MFN 06-262
Supplement 4

Subject: **Modified Reactor Building/Fuel Building Truncated Model,
SER-ESB-038 Rev. 5**

**Shimizu Engineering Report SER-ESB-038, Rev. 5,
“Modified RBFB Truncated FE Model Analysis Data,”**

Project	General Electric Company ESBWR Project	Shimizu Document No.	SER-ESB-038
Title	Modified RBFB Truncated FE Model Analysis Data	Rev.	5
		Issued Date	9/22/06
		Revised Date	1/9/07

Figure C-21 Element Forces Comparison NASTRAN to ANSYS (RCCV: Axial Force [MN/m])

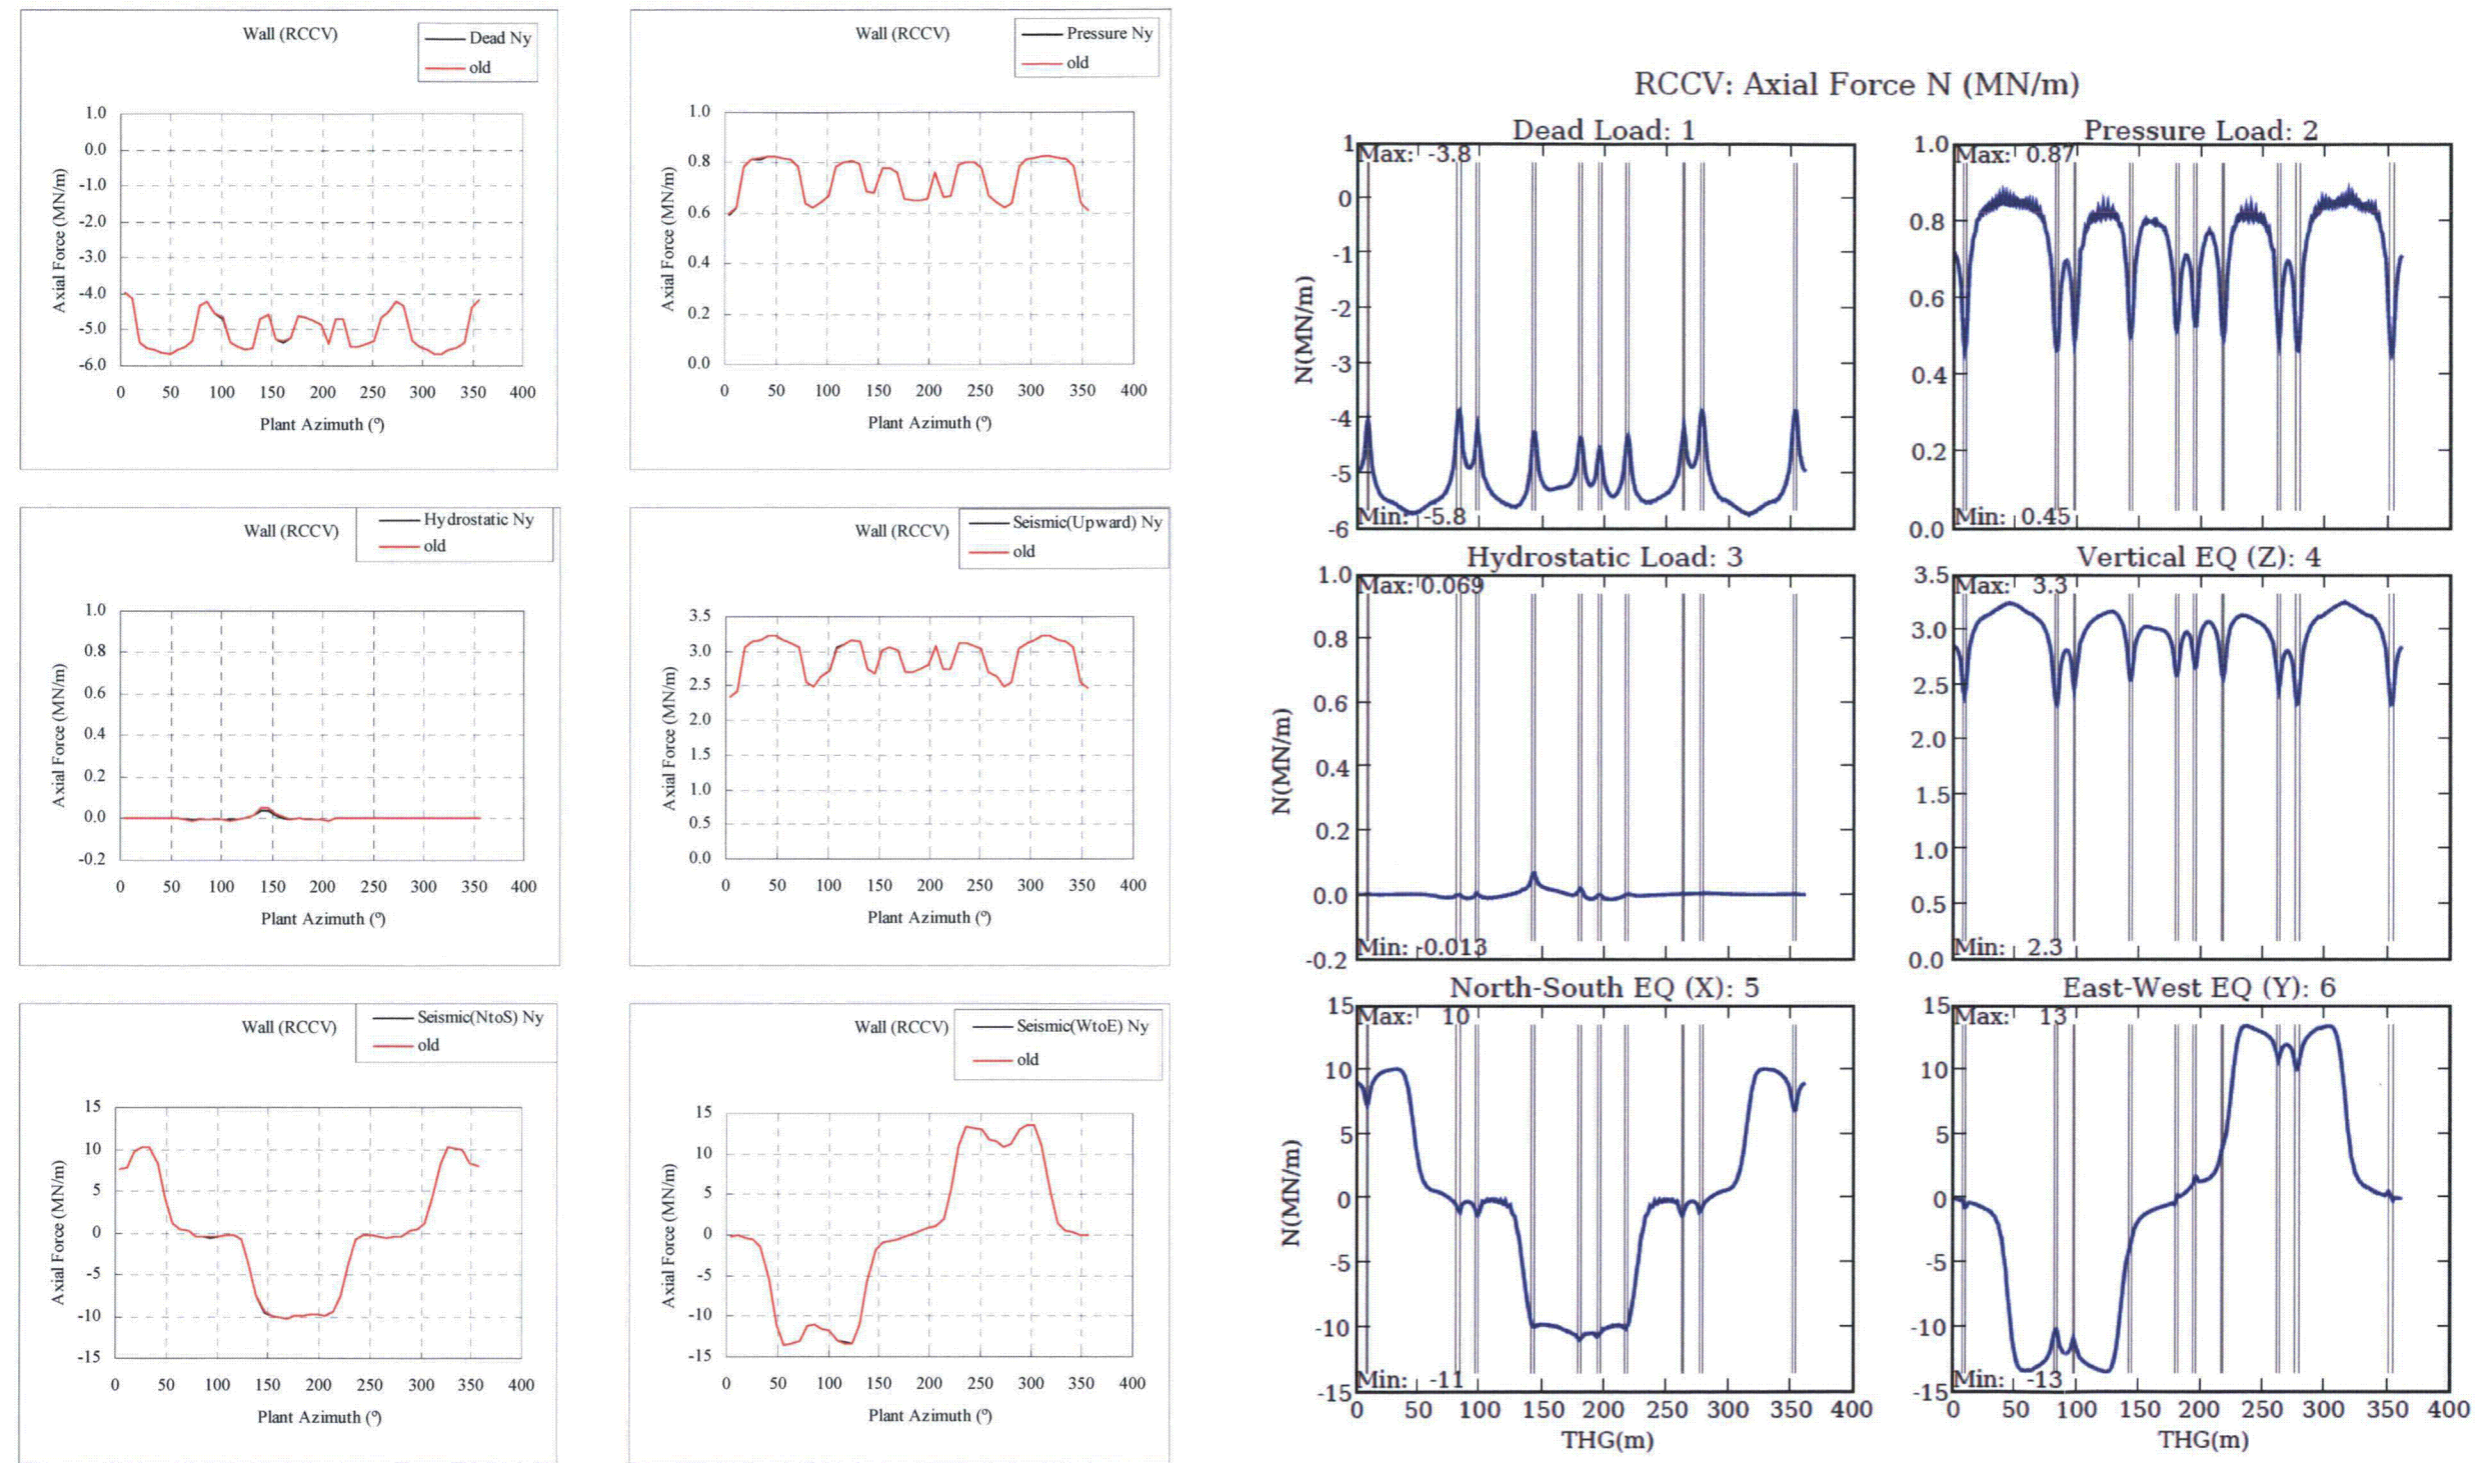
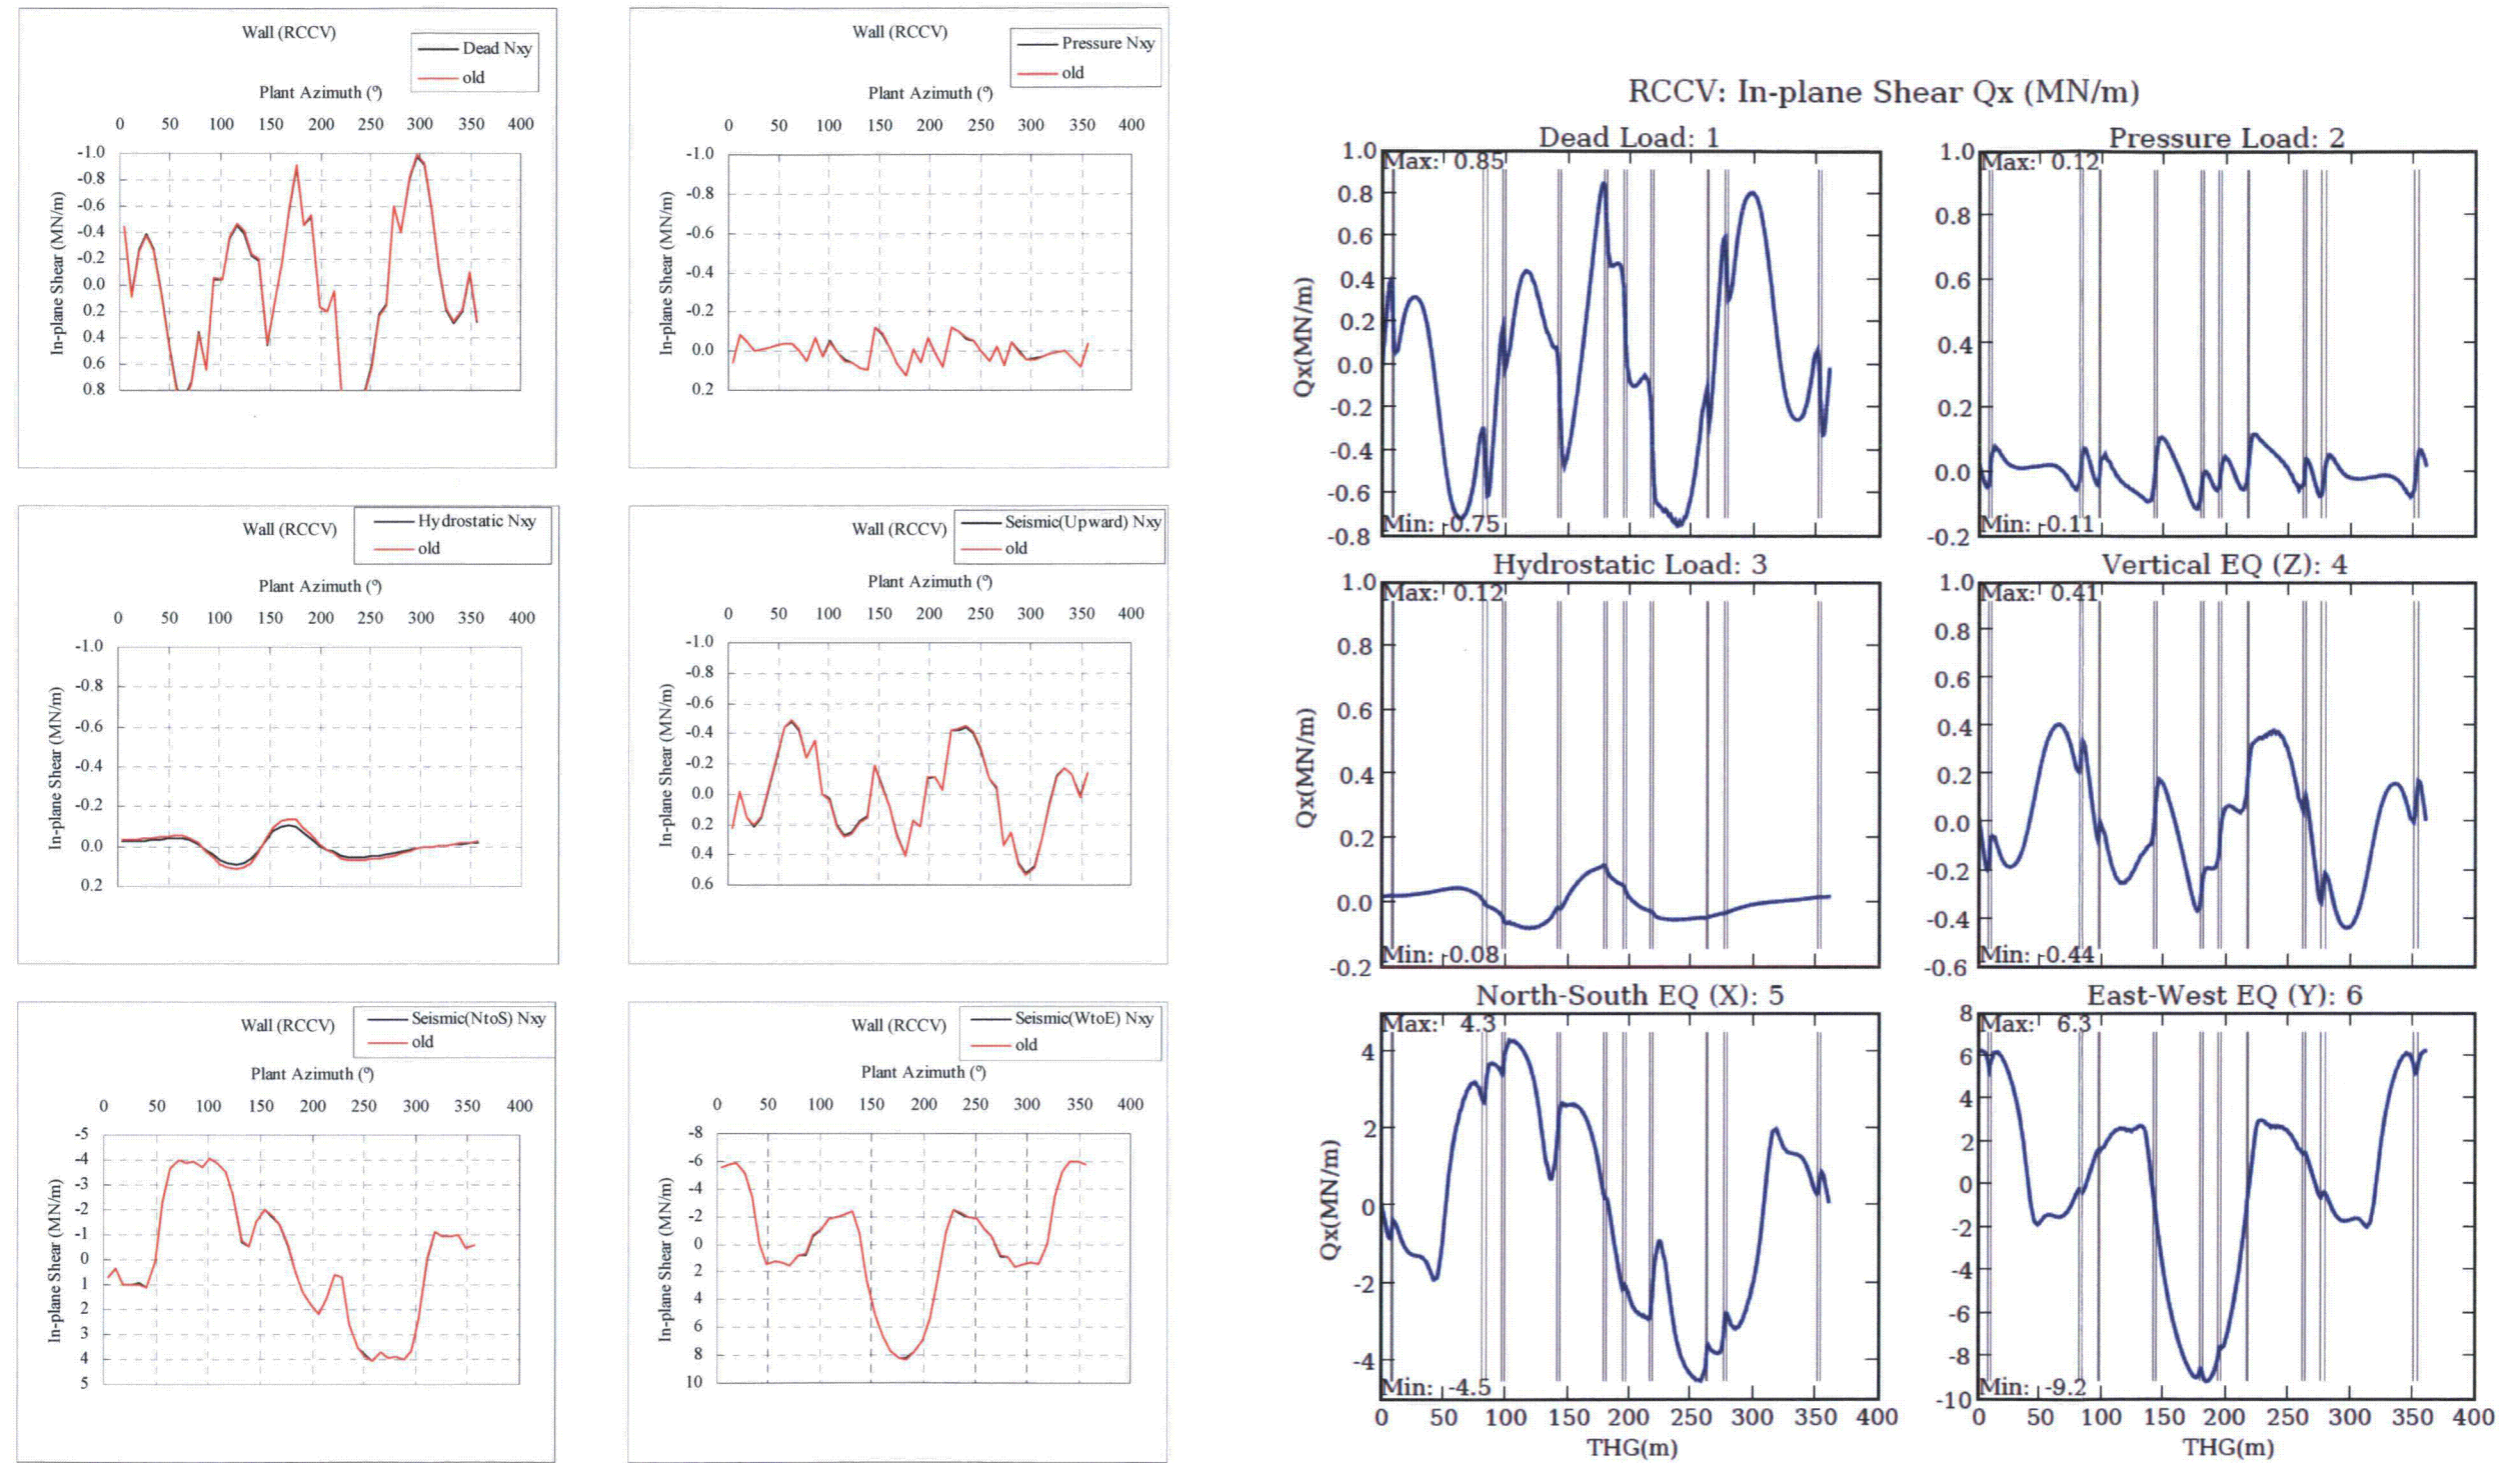
- iii) *The differences of magnitude of forces appeared on basemat inside pedestal:* The result of re-analysis using the updated model shows better agreement. In case of seismic load the magnitude of forces has to be re-compared because BNL's soil spring may not be adequate as pointed out above 3).

- iv) *The differences of magnitude of forces appeared on outer wall of Fuel Storage Pool (FSP):* For the out-of-plane shear forces and moments on RA and F3 wall located around FSP in case of Hydrostatic load, BNL's results are lower than those of GE. GE assumes the some part of differences comes from the difference of estimation levels between both models as pointed out above 8). In order to have a better understanding of the differences, GE would like to request BNL to confirm the input data for Hydrostatic load.
